Subject: DA2019/1284 Issues of concern regarding the proposed development of 54 Golf Parade Manly

RE: Submission re 54 Golf Parade Development Application Reference # DA2019/1284

Plan A

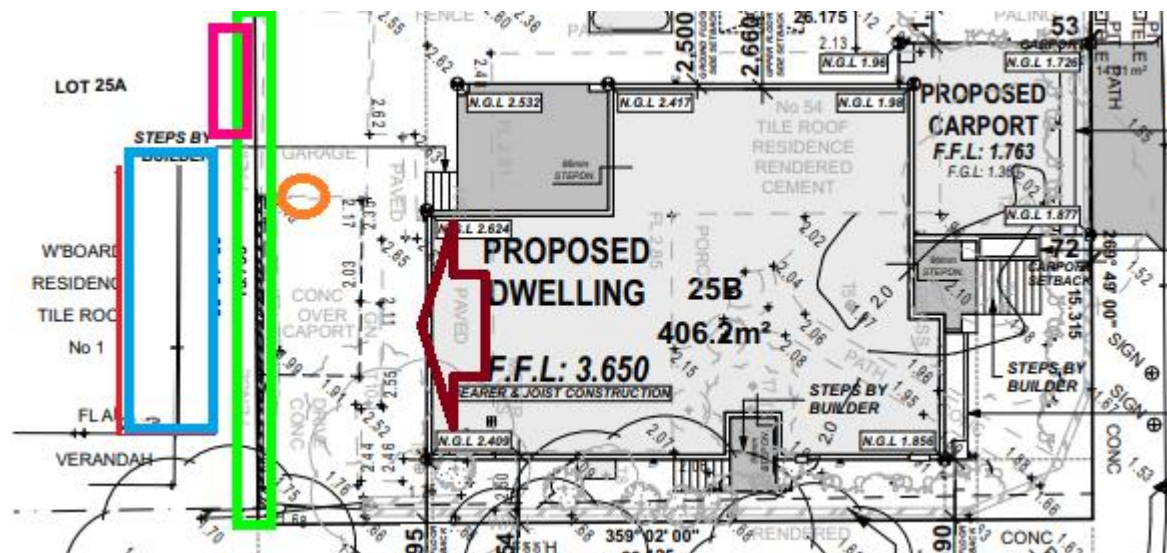
This non-compliance is a major concern for me. The height of the building looks very imposing and a significant change from the existing building. I understand flood level guidelines mean the property will be raised higher than a normal two story building, however the 2.6 and 2.75m ceiling heights are excessive and should be curtailed to a reasonable ceiling height standard of 2.4m. The roof pitch also adds another 2.364 meters which is excessive and almost adds another story to the building. The purchasers knew they were buying a property in a flood zone and are developers so are familiar with the Manly LEP and DCP requirements. It appears they have expected to get around these council standards and have applied regardless of them to build a large five bedroom house on a 420m² corner block! The roof has a 'decorative gable vent' in the pitch and an additional gable at the top just for aesthetics. It is unreasonable to request a Clause 4.6 Variation for the height which is contributed to by 2.6 and 2.75m internal ceiling heights and an aesthetic

roof design. The zone objectives are not to protect decorative and non-compulsory features. If this Variation is granted it will be directly violating the objective "to control the bulk and scale of buildings". The height has a direct impact on privacy and solar access. The height, with the exception of some more modern out of character buildings is not consistent with the prevailing building height and streetscape character.

My property is over 100 years old, If Manly Council thinks that allowing a building next to it of 9.9m is 'retaining the streetscape character' then it is not acting in the residents' interests.

The flood management plan has recommended the use of 'flood fences' (which have a gap of 100mm at the bottom to allow flood waters to pass). I have significant, *grave* concerns with this type of fencing and **do not agree** to this type of fencing being installed. My property has brick fences all the way to the ground on all surrounding boundaries, including the current fencing on the north side of the proposed development which is INCORRECTLY marked on the plans as a PALING FENCE, when in actuality it is a 100cm rendered double brick fence, topped with palings that provides a flood barrier for my property (refer to green markings on plan above). If this 'flood fencing' is erected then water will pass under this fence and get trapped in my house due to the other impervious fences not letting the water escape. There is no doubt that my property will then flood.

There are large louvered windows on the lower floor as well as windows directly above on the second floor (refer to red markings on Plan B above) proposed on the rear of the building, so from inside they will be able to look directly into our backyard and bedrooms. Bedrooms marked in blue on Plan A.

There is a water feature proposed approximately 300 cm from my bedroom window (highlighted in orange on Plan A) and I have a significant concern about the noise pollution from this feature (my children and I can hear the ocean at night when lying in bed and I fear this will be blocked out by the noise of the water feature).

Request: Reduce internal ceiling height to 2.4m and amend the roof pitch to smaller than 2.364m.

Request: That the property's northerly fence be of the same flood-proof efficacy as it is currently (note that on the DA it refers to the new fence as 'acoustic fence'). I also expect that this replacement fence will be fully funded by the neighbour.

1. Please replace all bamboo on plans with another (native) plant species that won't grow more than two metres on the northern side of the boundary.
2. Please place water feature at the front of your property.

Does not comply with LEP requirements:

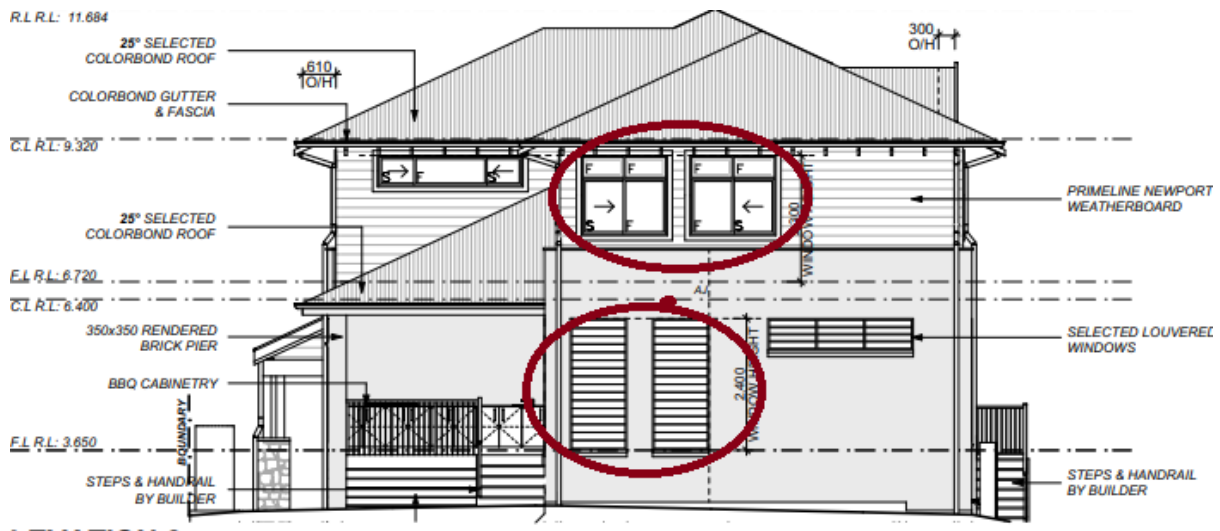
Hall and Hart have stated on the 'Statement of Environmental Effects' that "the proposed development has been designed to comply with Manly DCP and LEP". However there are significant and numerous non-compliances and it seems that no care or intent to comply with LEP or DEP requirements was considered upon purchasing, and that the developers have had a preconceived design not sensitive to the local area and controls. The compliance table 2.4 on the Statement of Environmental Effects has 14 LEP and DCP Controls - out of these 14 controls, 8 are non-compliant on the DA submission which is over 50%. Maximum Floor Area is not compliant, the justification of this was that to comply with FFL restrictions they have to not comply with FSR restrictions(?). The justification describes the addition of a 'theatre room' as 'unnecessary', and this theatre room was not actually required but rather the result of having a spare space to use up after the carport became detached from the house to meet council guidelines. My major concern is that the Minimum open space is approximately half that which the Manly LEP and DCP require. This is associated with the significant noncompliance with set back from rear boundary. This matter has attempted to be explained away by 'Justification' that allotment is not very deep - however this is exactly the reason for the set back principle - so that smaller lots are not over-built at the expense of other smaller lots amenity. The new occupants purchased a lot of a certain size - that was their choice - in smaller lots especially, occupiers (me and my children) rely on council for protection (via compliance standards) from over-building.

Request: The bulk and footprint of the building be reduced and the amount of green space increased.
